# Ajax Mine Project

Joint Federal Comprehensive Study / Provincial Assessment Report

August 2017

Figure 3: Jacko Lake Dams

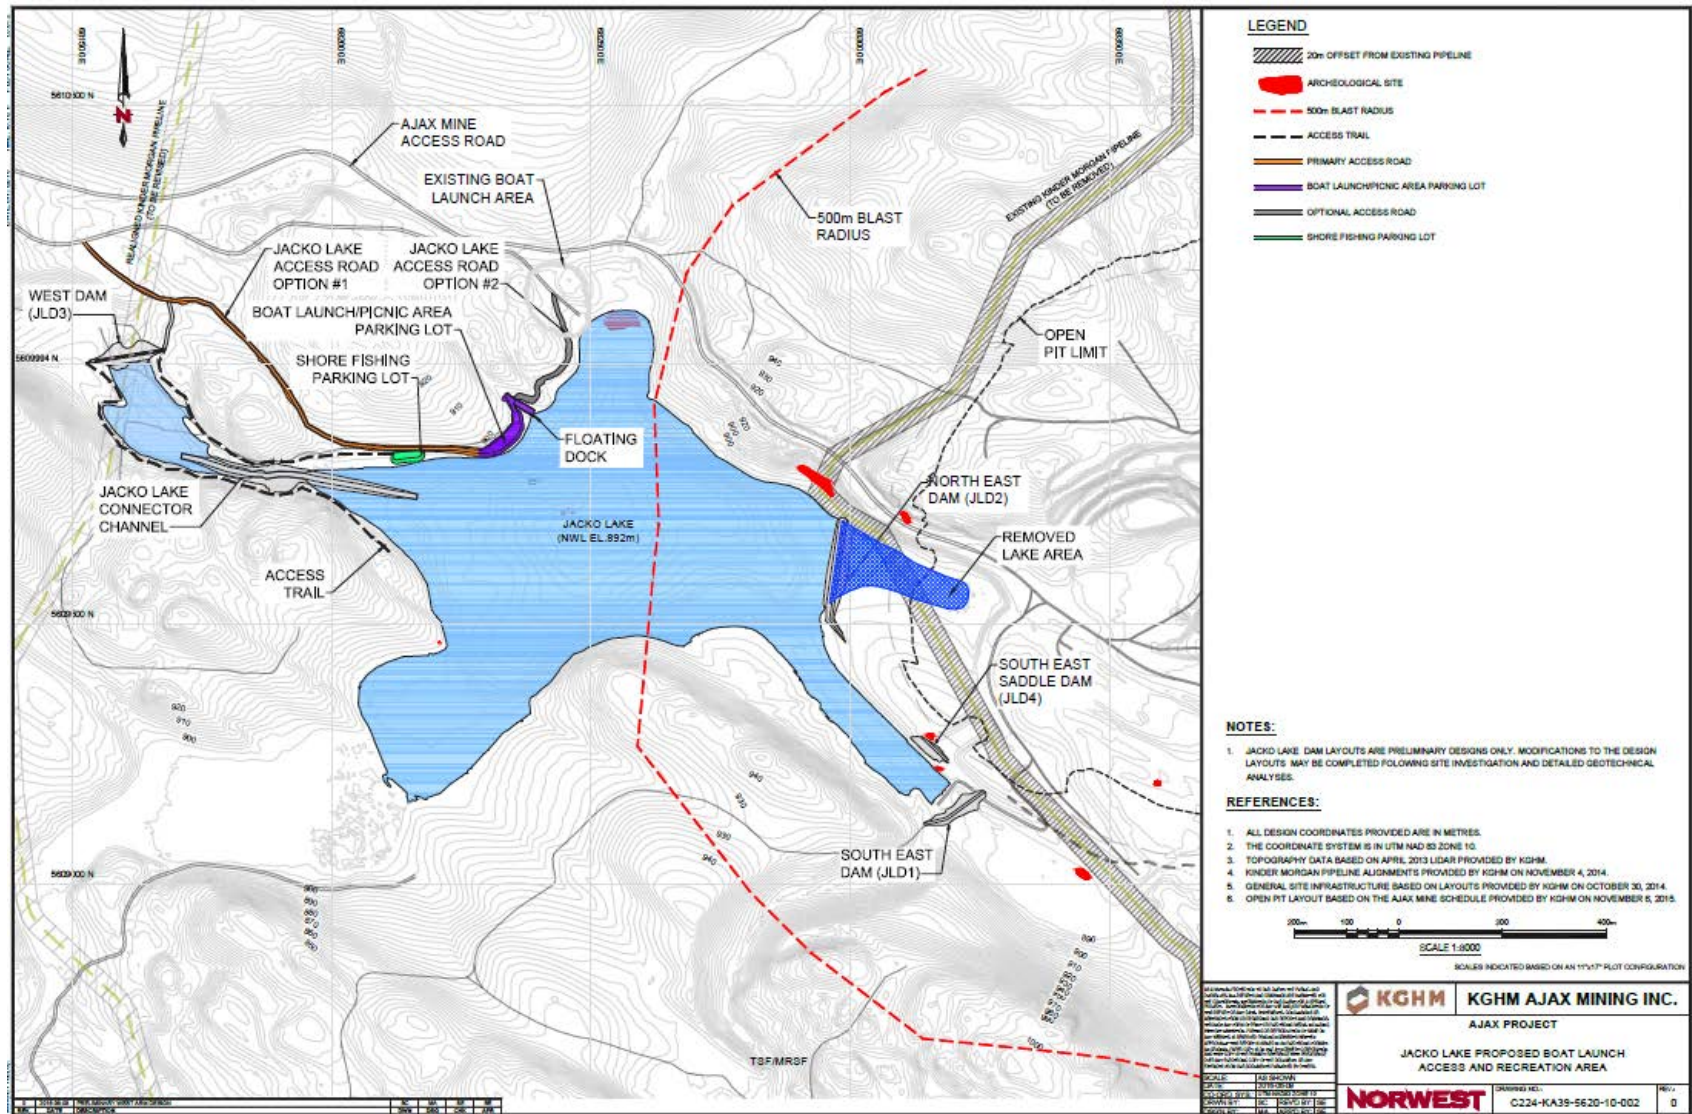
MFLNR, DFO, and ECCC raised questions regarding the range of variability in Jacko Lake water levels with the construction of the Jacko Lake dams (refer to Figure 3 below). Reviewers questioned how lake level fluctuations could affect existing littoral habitats and the downstream flow regime on Peterson Creek. MFLNR also noted that a dam breach analysis and inundation study at the southeast dam on Jacko Lake would be required, and that the updated design of the Peterson Creek diversion system could increase the consequence rating of this dam.

KAM indicated that the normal operating level of Jacko Lake would remain at 892 m above sea level. The dams would be designed to contain a large precipitation event and would provide protection against flooding. The design crest elevation of the proposed dams is 895.5 m above sea level, which would provide a storage capacity greater than twice the estimated Probable Maximum Flood levels. During heavy precipitation events, controlled releases of water from Jacko Lake would help limit potential impacts to riparian and shoreline areas. The increased lake storage would also provide additional water supply in wet years that could result in a longer duration of increased streamflow throughout the irrigation and low flow seasons to better meet environmental flow needs for fish and other aquatic organisms. The timing and rate of release from Jacko Lake would continue to be regulated by MFLNR and operated by the water bailiff to ensure flow requirements for downstream water licence holders, as well as ecological needs. The EAO notes that the additional storage capacity that would be created in Jacko Lake by Ajax would require an authorization from MFLNR under the *Water Sustainability Act*.

Figure 4: Edith Lake Fault Zone

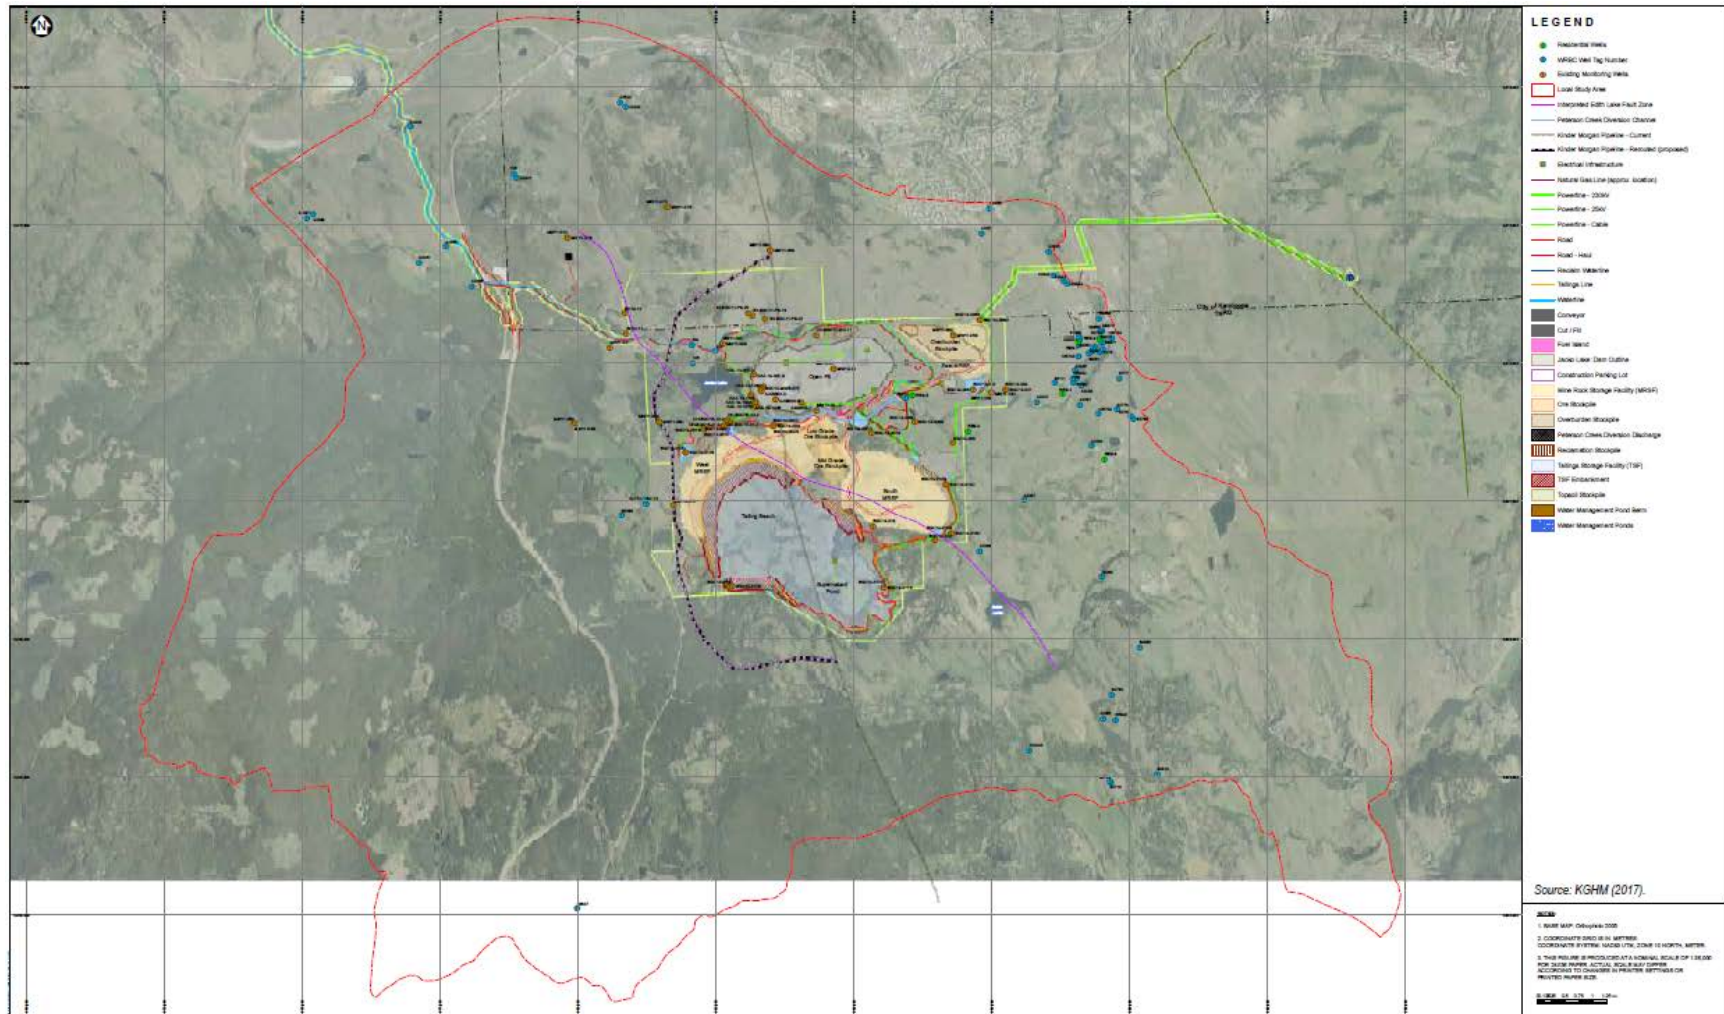
ECCC, NRCan, MFLNR, SSN, the City of Kamloops, and members of the public were concerned that the Edith Lake fault zone could potentially act as a conduit for contact water from the tailings storage facility and mine rock storage facilities to Jacko Lake and degrade water quality. The Edith Lake fault zone is a northwest-southeast trending geological structure which underlies portions of Jacko Lake, the planned north embankment of the tailings storage facility, the west mine rock storage facility, and the south mine rock storage facility.

In response to the identified uncertainties related to the Edith Lake fault zone and groundwater movement at the site, KAM undertook additional sensitivity analyses to assess the effect of variations in the hydraulic conductivity of the Edith Lake fault zone. The results of the higher hydraulic conductivity simulations indicated that the increased groundwater discharge to Jacko Lake that included seepage-affected water from the tailings storage facility and west mine rock storage facility, could potentially impact water quality in Jacko Lake. However, KAM noted that this scenario would be unlikely to occur, since KAM would be able to detect changes in groundwater flow in the event that the hydraulic conductivity was higher than predicted, and would be able to adaptively manage the effect by implementing measures such as installation of interception wells, cut-off walls, horizontal drains, and grouting. KAM also indicated that groundwater movement through the Edith Lake fault zone in the base case is not predicted to affect water quality in Jacko Lake.

NRCan agreed that KAM's modeling has considered a conservative worst-case scenario for conductivity of the Edith Lake fault zone, and that the proposed monitoring and management program is likely to complement the numerical model capabilities to provide protection of water resources in the vicinity of Ajax.
